# Irvine Campus Medical Complex

## Final Subsequent Environmental Impact Report

January 2021

3. THE DEIR FAILS TO PROVIDE PLANS FOR ADDRESSING BIRD-BUILDING COLLISIONS.

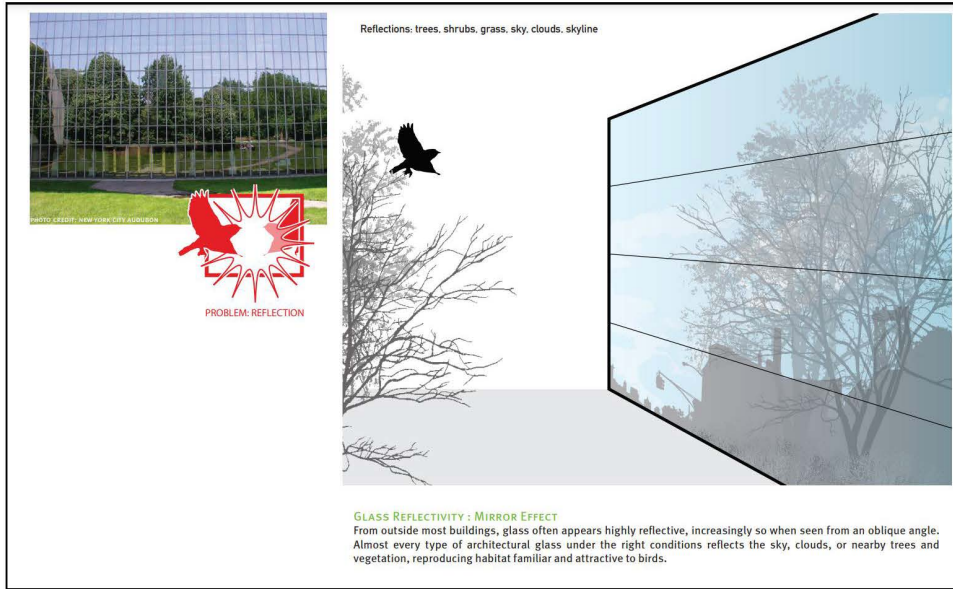
a. The project would site a glassy multi-story building adjacent a significant migratory stopover within the pacific flyway and an important breeding area for threatened species. One of the leading threats to birds from humans are collisions with buildings.
